Report to Development Permit Panel

To: Development Permit Panel
From: Brian J. Jackson, MCIP
Director of Development
Date: May 20, 2011
File: DP 05-299968
Re: **Application by Harco Homes Inc. for a Development Permit at 7560/7580 No. 2 Road**

Excerpt from the Minutes from
The Design Panel Meeting

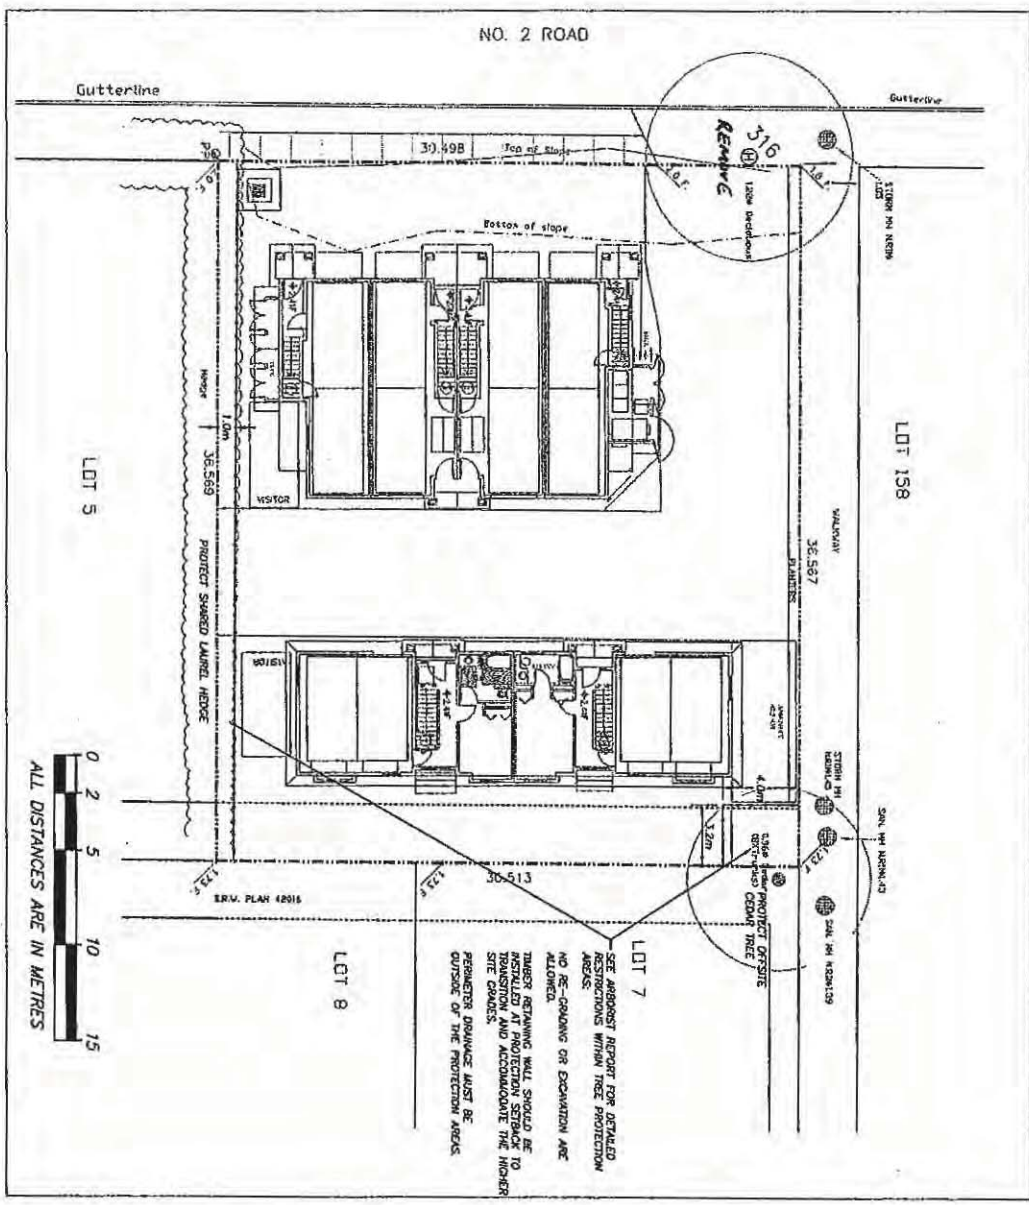
6. Would a variance be allowed to move building over to put more landscape and relocate amenity provisions.

Amenity is located at north east corner. The only variance requested is the 0.57m electrical closet into the south sideyard setback.
